RECEIPT DATE: 7/24/23 **ONSITE SEWAGE DISPOSAL SYSTEM** P 574964

PROPERTY ADDRESS: 1872 Woodbine Road

SUBDIVISION: Browning Property LOT: 1 TAX ID: _____

SEPTIC SYSTEM
 INSTALLATION SITE PLAN
 BROWNING PROPERTY
 LOT 1

Let me know if you have any questions.

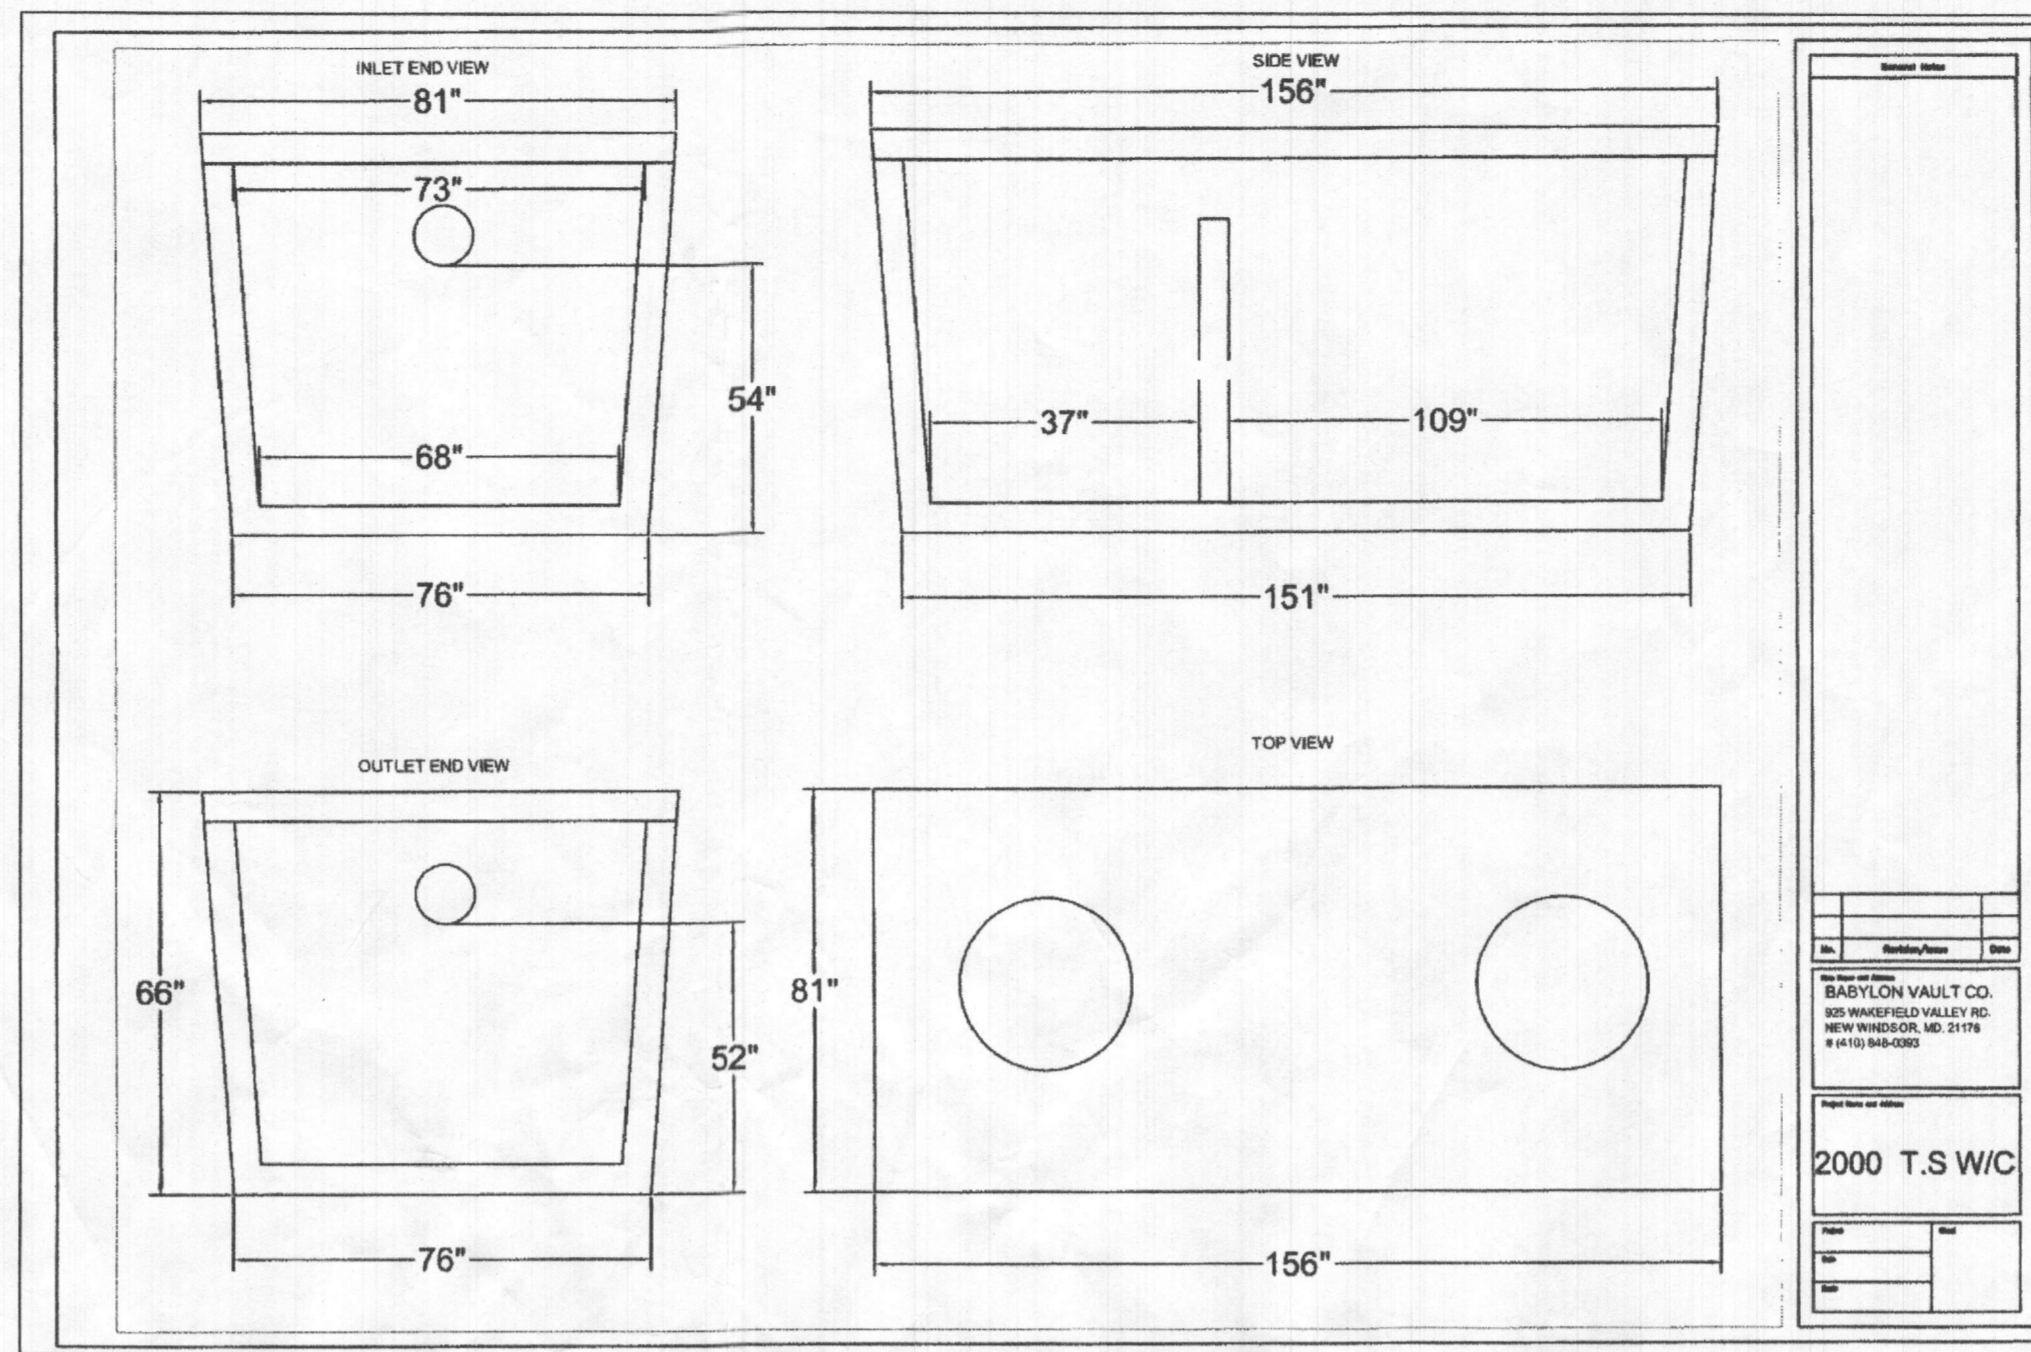
The following comments pertain to the review of the Browning Property Lot 1.

- 1.) Add new address to plan 1872 Woodbine Road. Address was added
- 2.) Relocate drywell (1B). It's within 25 feet of the SDA. Drywell was moved
- 3.) Raise septic tank. Tank is more than 3 feet below grade. Grading was revised for tank depth to be 3'
- 4.) Raise trench invert (if possible) for better use and design of trench. Trench invert is at max depth. Trench depth was set at 4' to allow basement gravity.
- 5.) Ensure trench spacing is being met for all systems. Trench spacing is at 11' for initial system perc spec.

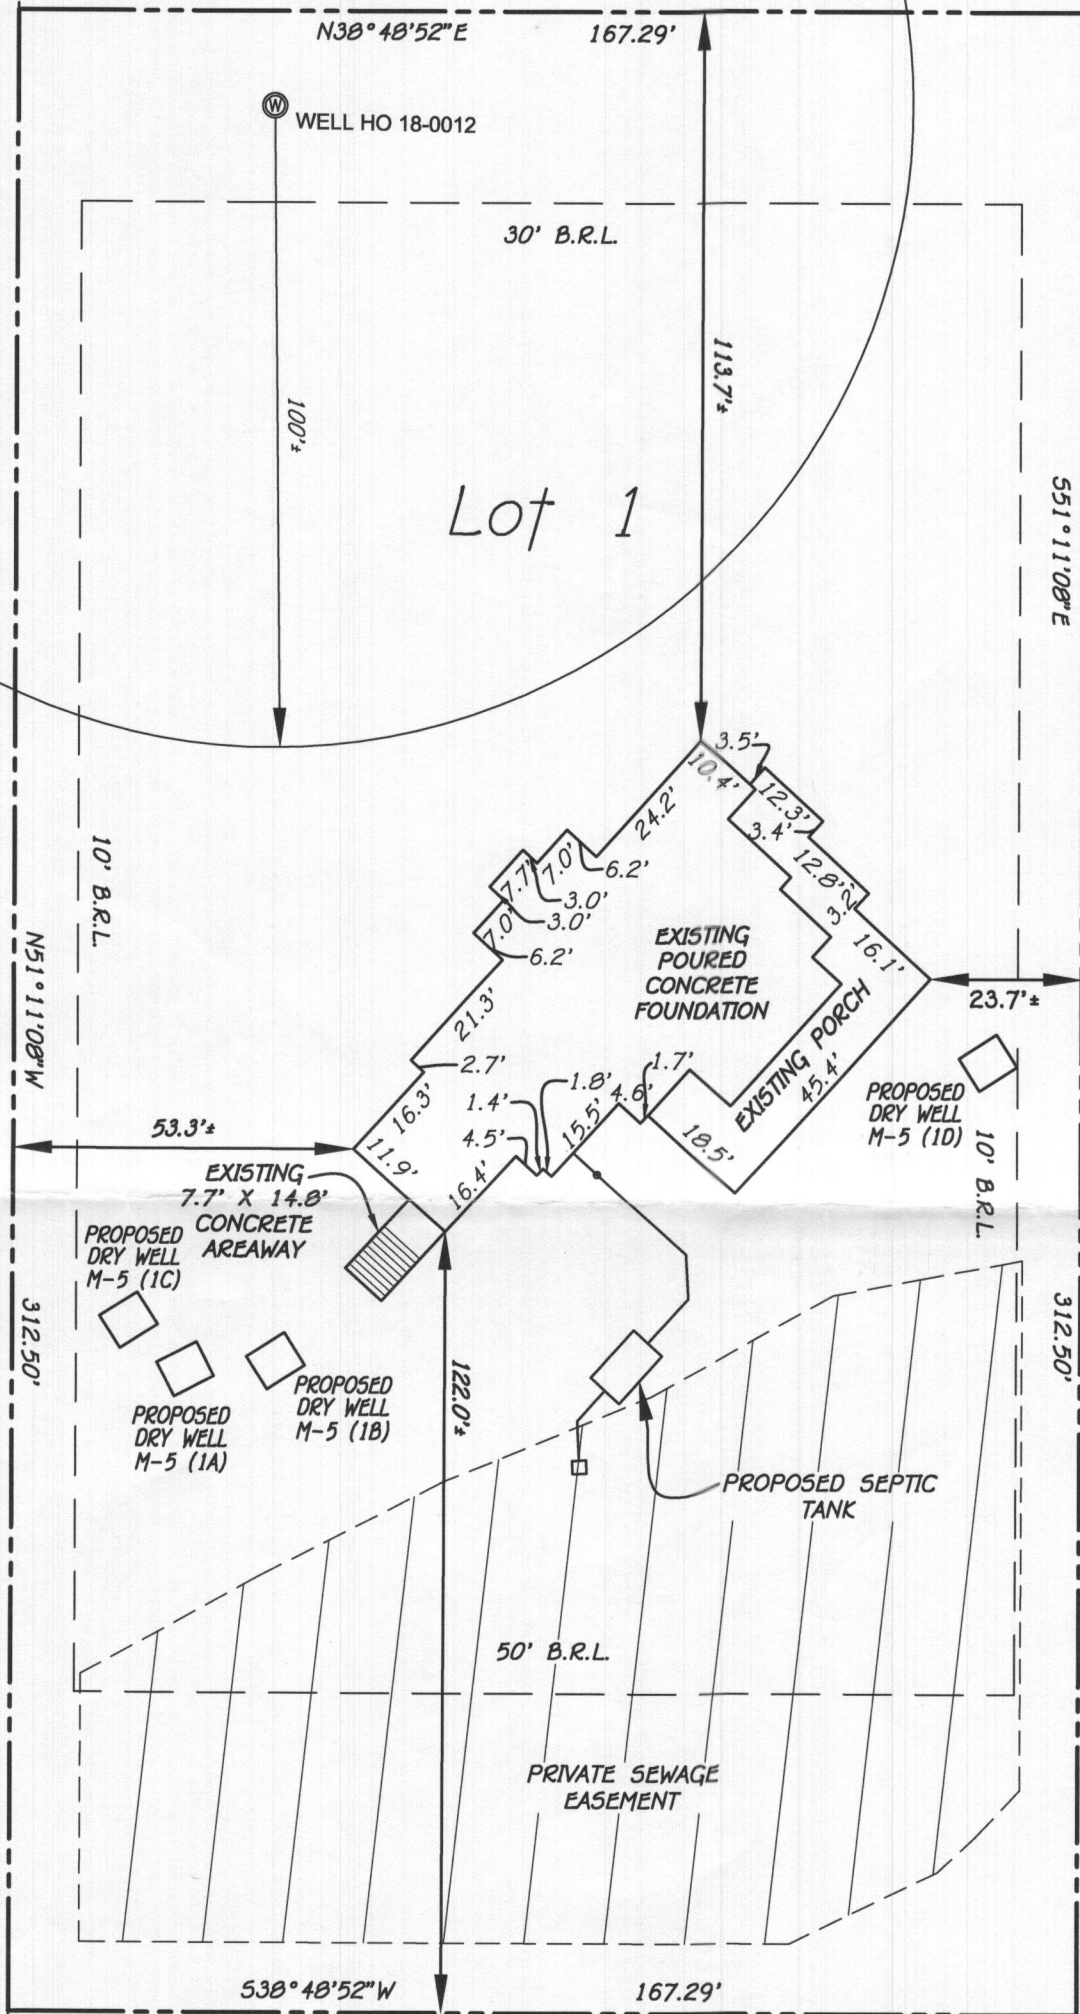
I reviewed the OSDS Plan for the Browning Property, Lot 1. There is a 28 % slope within 25 feet of the sewage disposal area. Perhaps the house site can be adjusted toward the well sites to accommodate the grading adjustment.
